DATE: 11.28.2018
TO: ProTrak
FROM: Mitesh Baxi
Traffic Engineering

■ **POINTE AT BARCLAY STREET AND UTILITY EXTENSIONS [Subdivision Plan Review]**

↻ Initial Review Note ↻

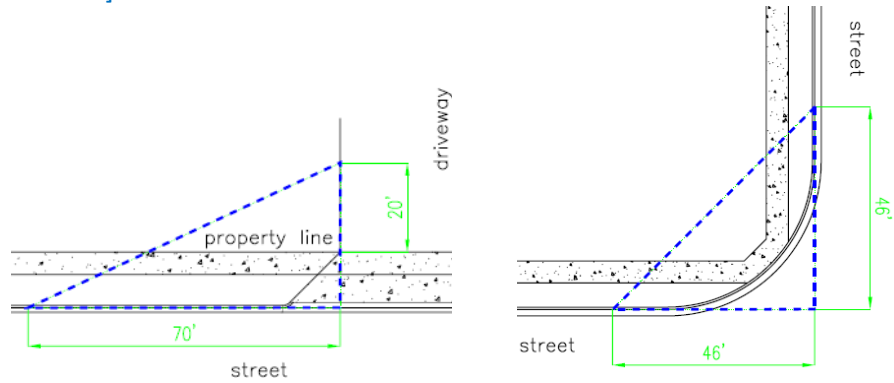
- Revise all relevant sheets to accurately illustrate the existing conditions on and surrounding this parcel. Show all adjacent traffic signs, lane configurations, traffic control devices, pavement markings and street lights for both the roundabout intersections on Gallery Park Blv on the site plan. Please refer to the Technical Standards and Specifications Manual (link is below) Ch. VII C.1.a.2. for specific information and distance requirements. Contact Traffic Engineering at 341-7888 if you need assistance locating these elements.
<https://www.wilmingtonnc.gov/home/showdocument?id=1910>
- Please clarify if Dusty Miller Lane is a private or public ROW.
- Please show the locations of the existing street lights on Gallery Park Blv.
- A standard street light plan (as per City’s Street lighting policy) will be provided, along with the next response, based on the above information.
